ADDENDUM NO. 7

HVAC & CONTROLS REPLACEMENT/ADDITION AT NINE (9) SITES: BARRANCA, BEN LOMOND, CYPRESS, GROVECENTER, MANZANITA, MERWIN, MESA, ROWLAND, AND WORKMAN ELEMENTARY SCHOOLS RFQ/RFP #22-23-105

January 19, 2023

BUILDING J MECHANICAL FLOOR PLAN
SCALE: 1/8" = 1'-0"

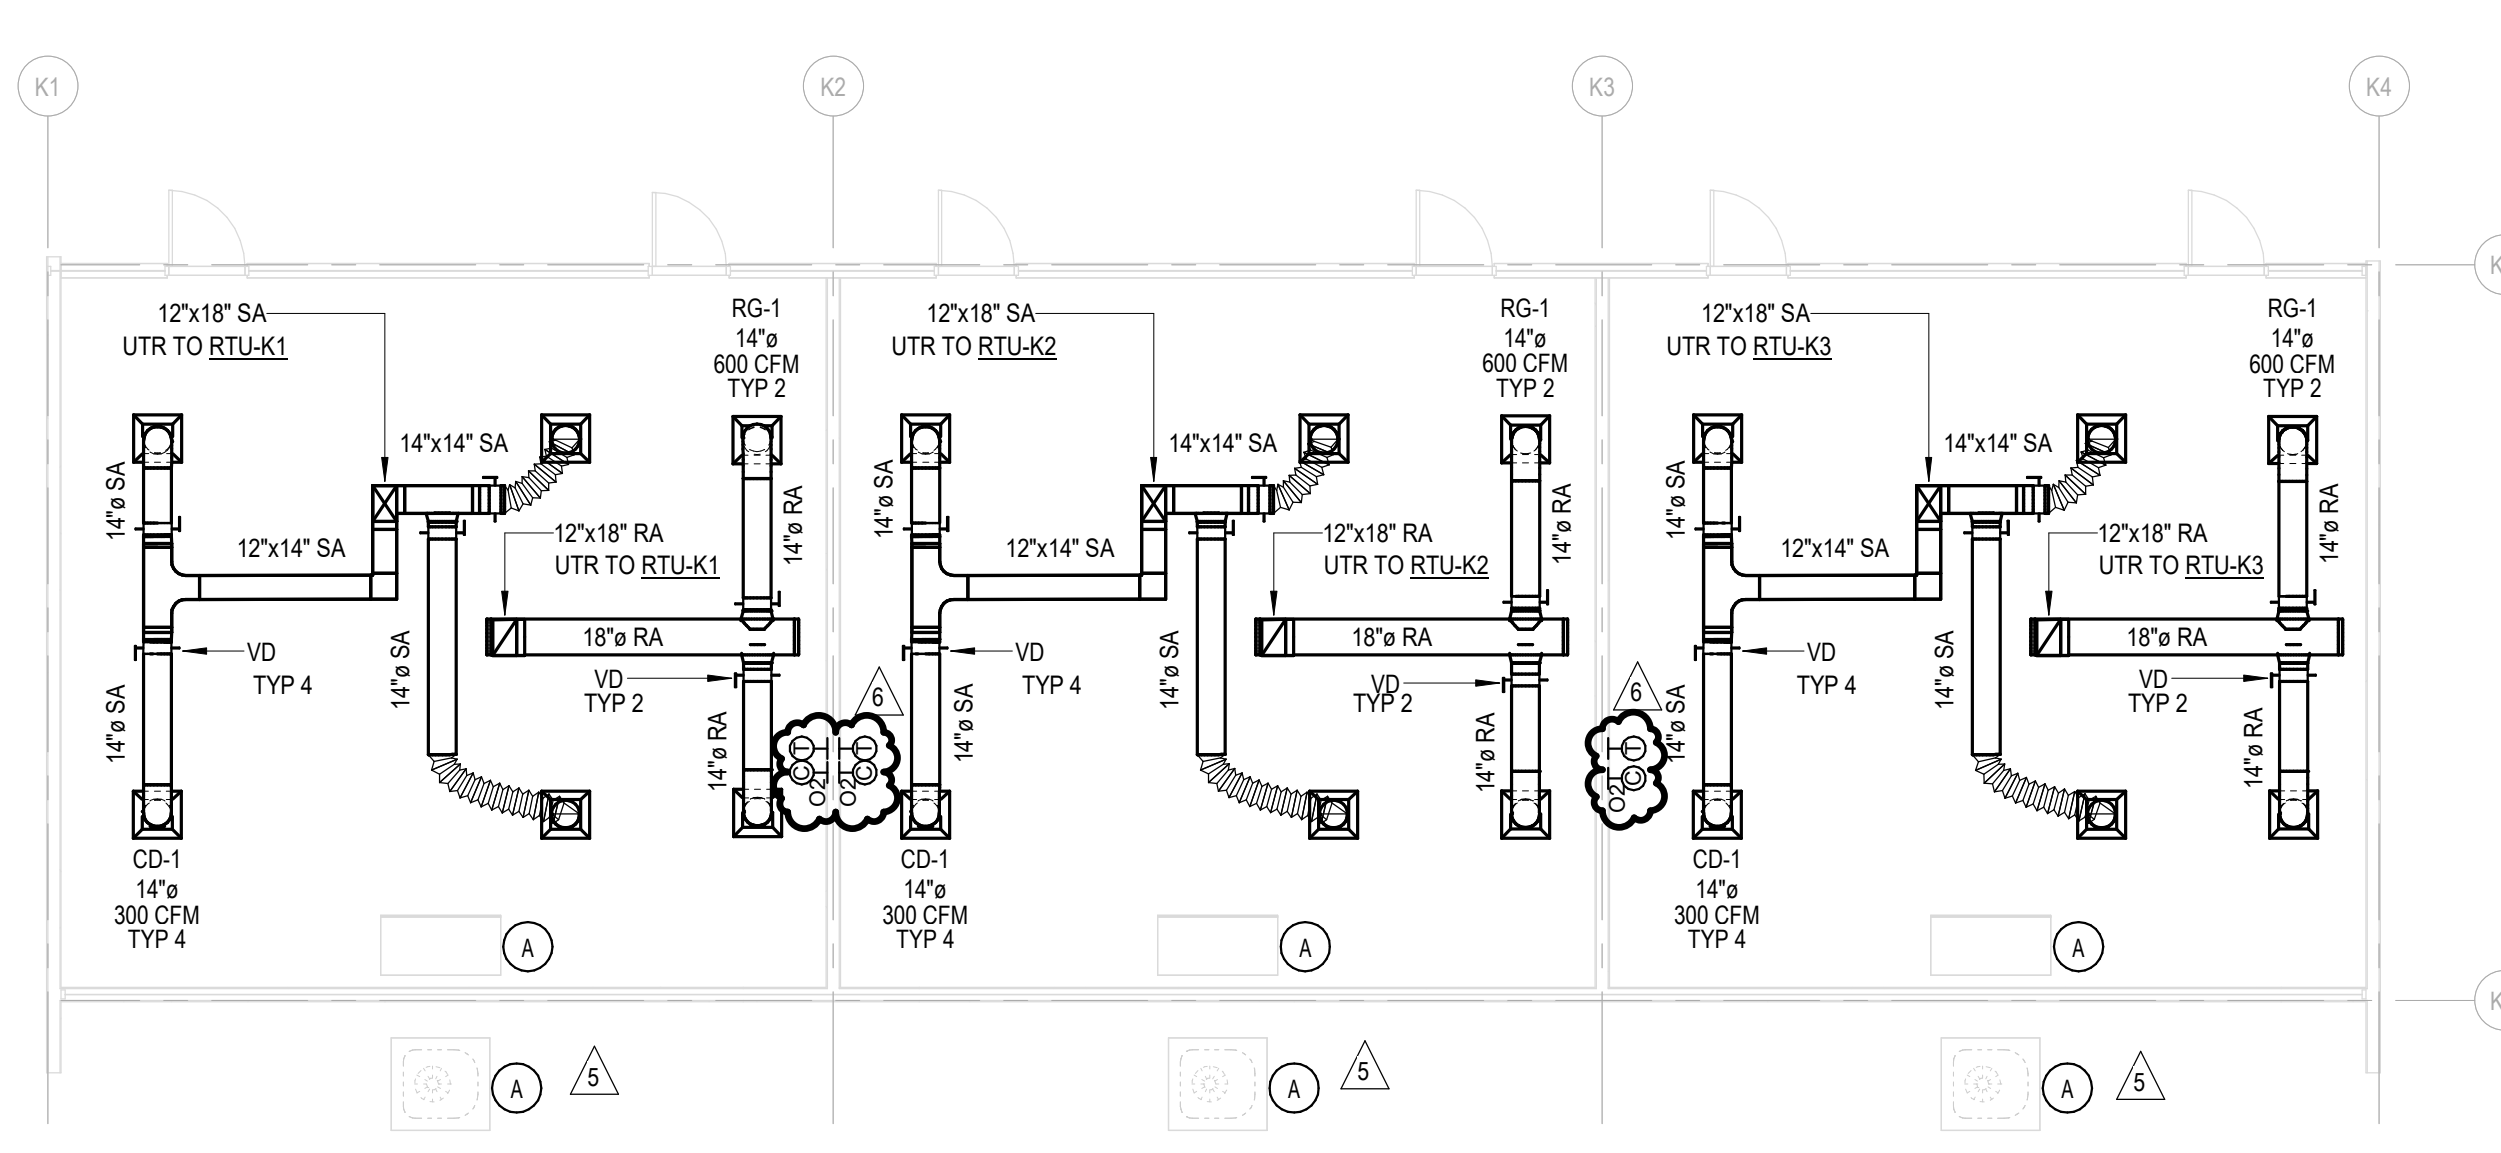
(Page M1.1A)

-Building H: RTU-H2 There is T stat locations on both walls on GL E2 and E3. Please confirm what wall the sensor is to be located.

DLR Response: See attached updated drawing M1.1A. Also, CO2 sensors are added in each classrooms same as the other schools.

M1.1F

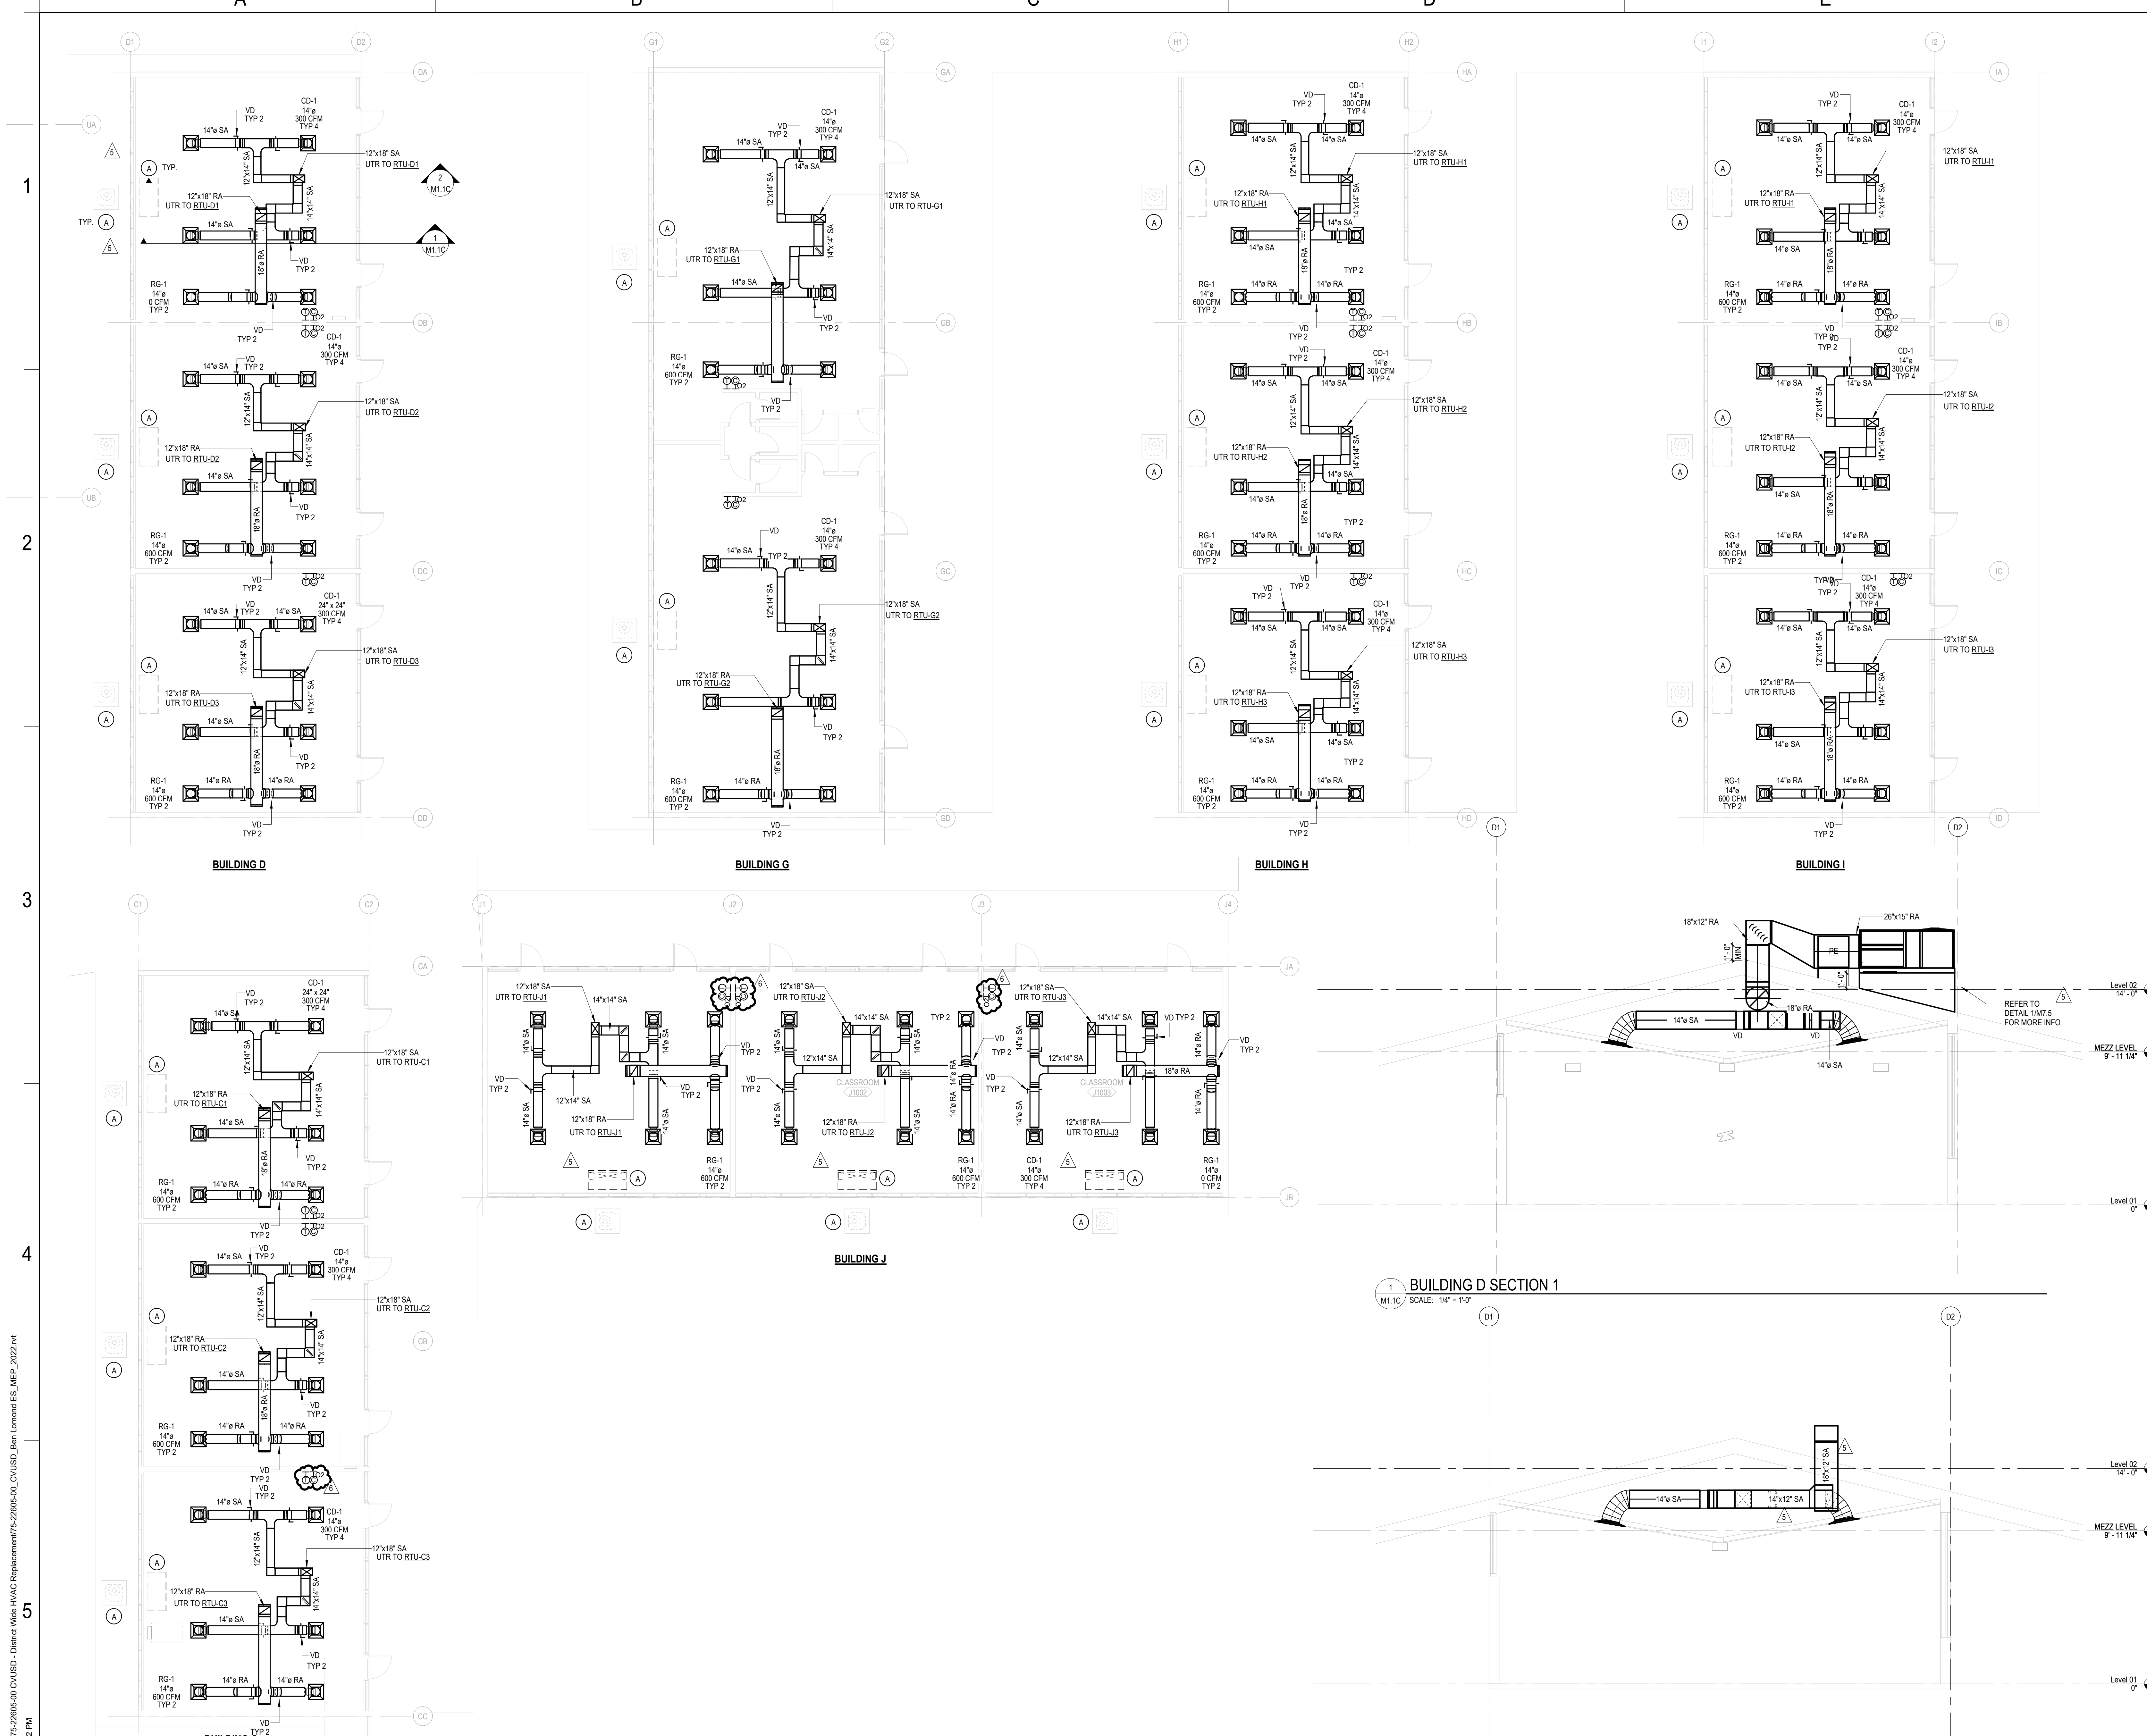
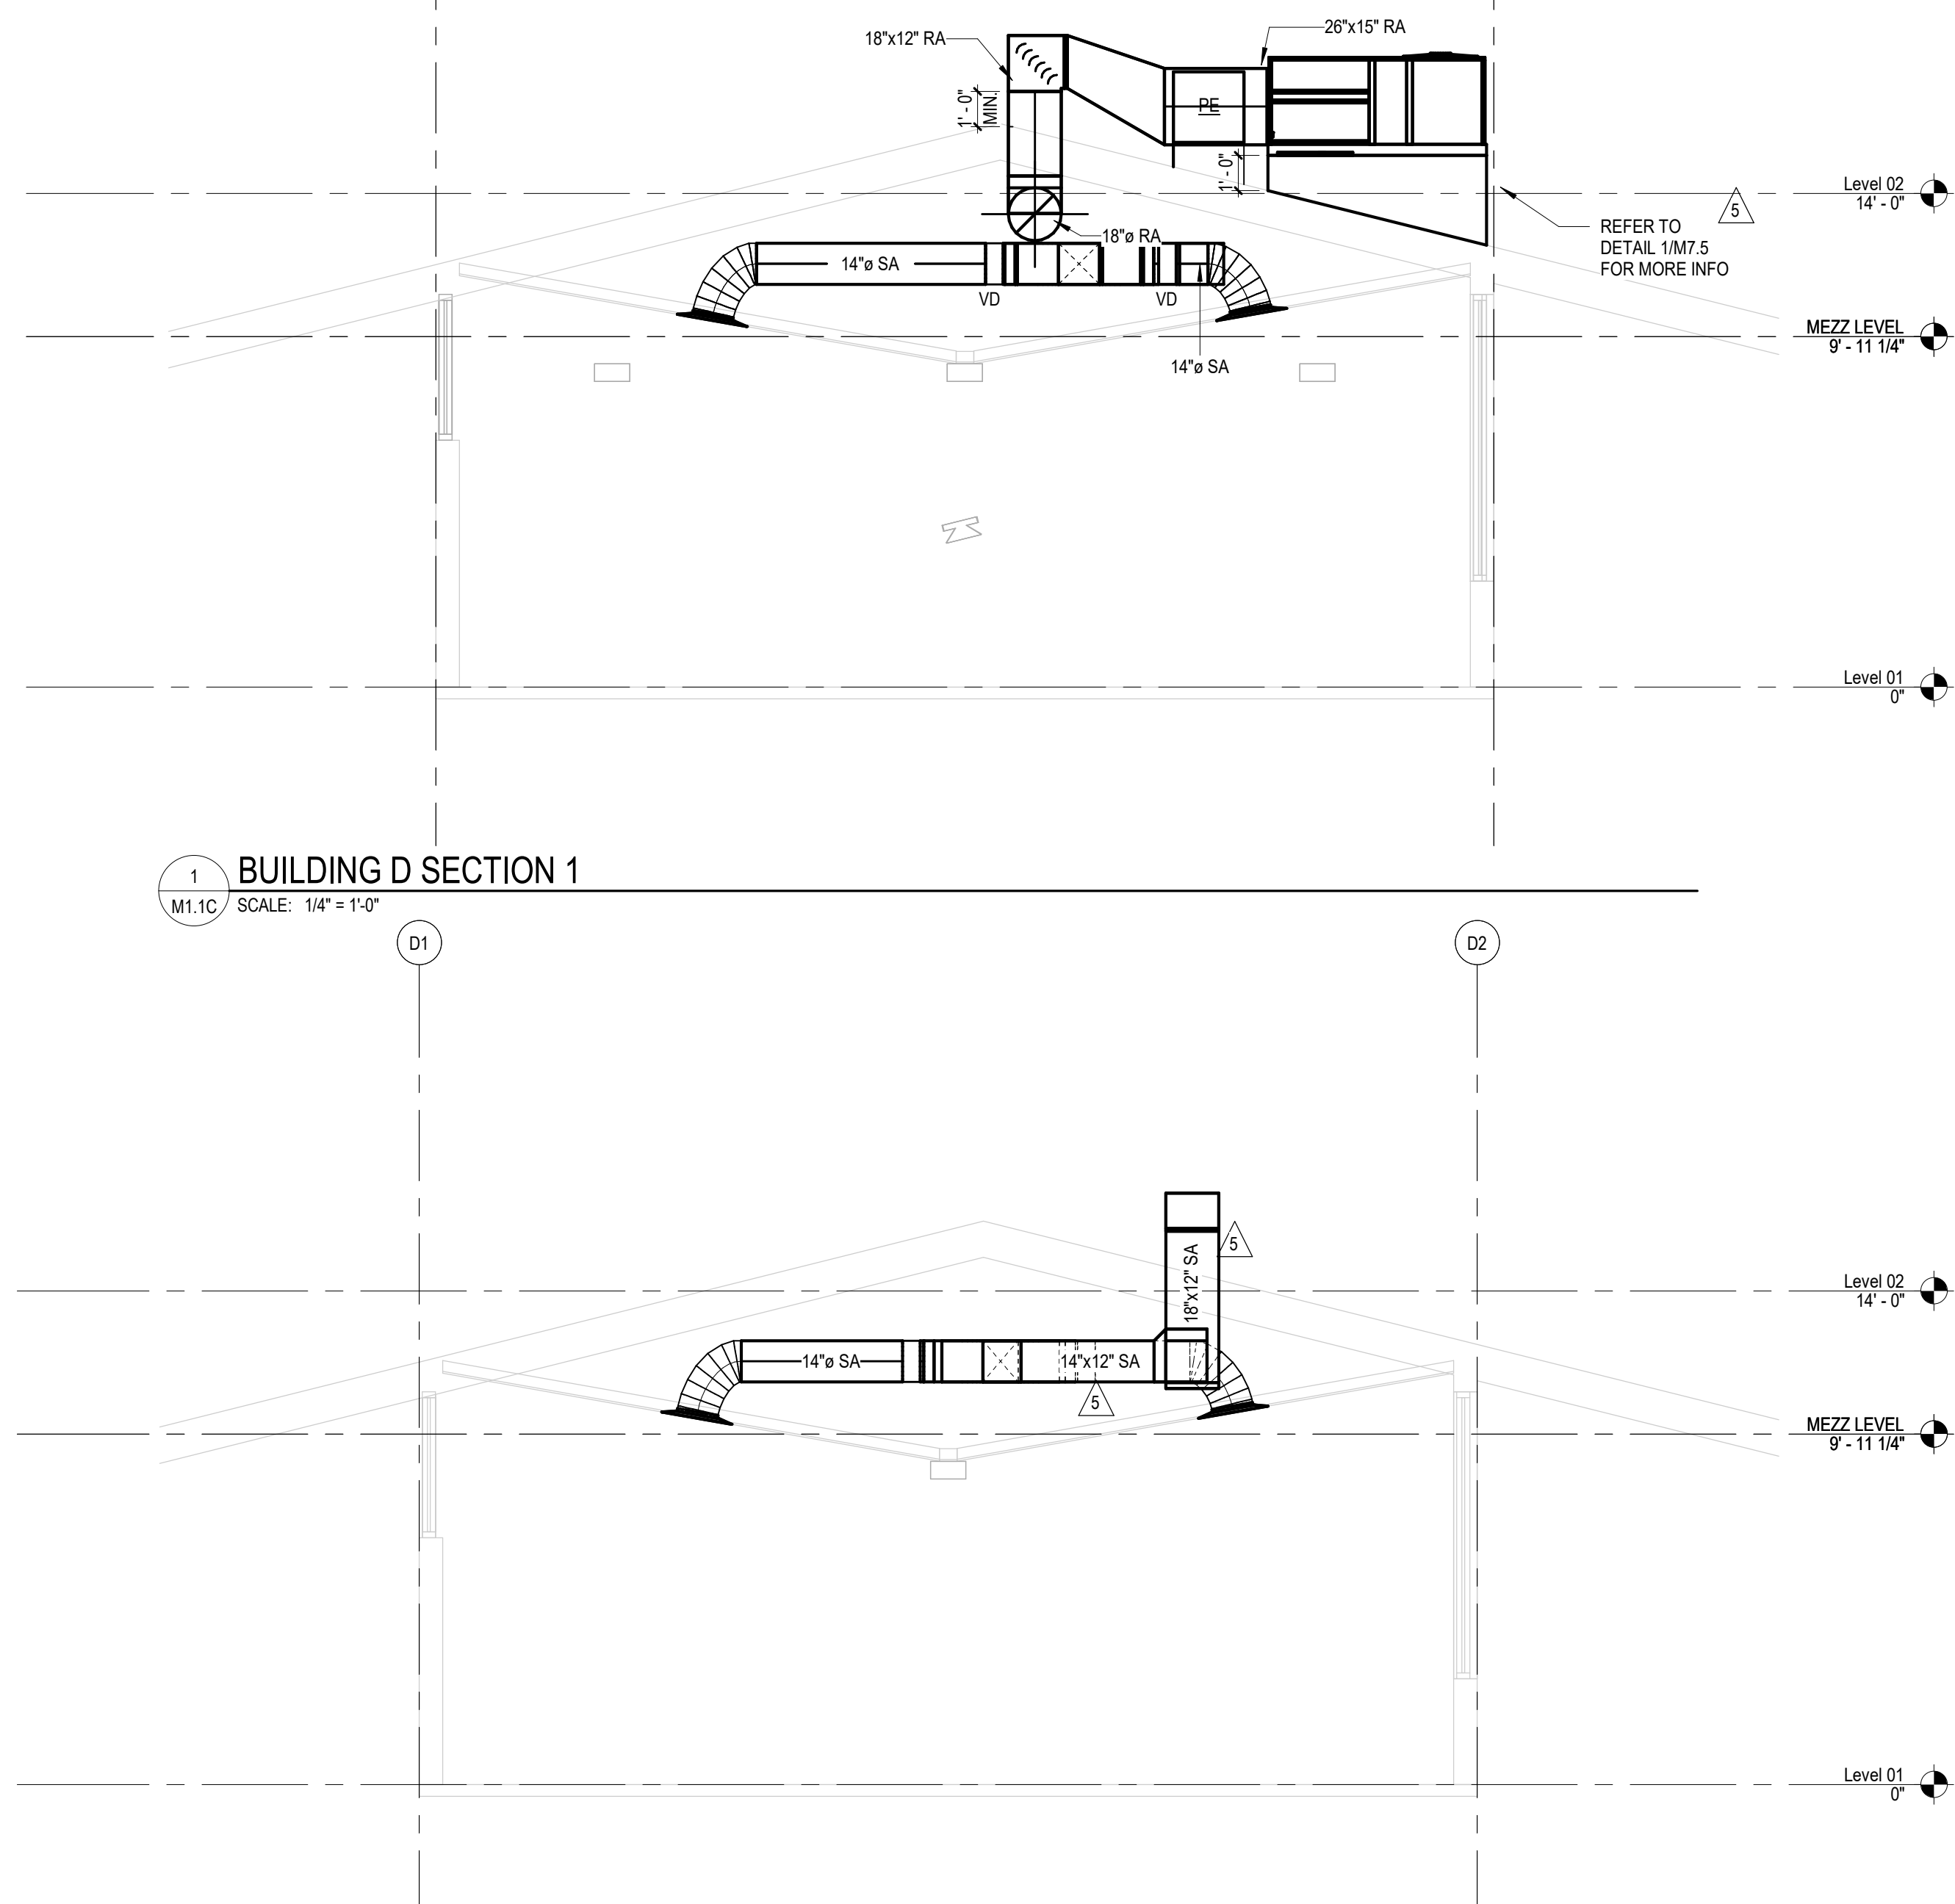
(Page M1.1F)

-Building K: RTU-K3 There is no Co2/T stat in the room served please confirm Co2/T stat location.

DLR Response: There is a set of CO2/T stat on M1.1F for RTU-K3 in Classroom K1103. See attached red-marked plan for reference only.
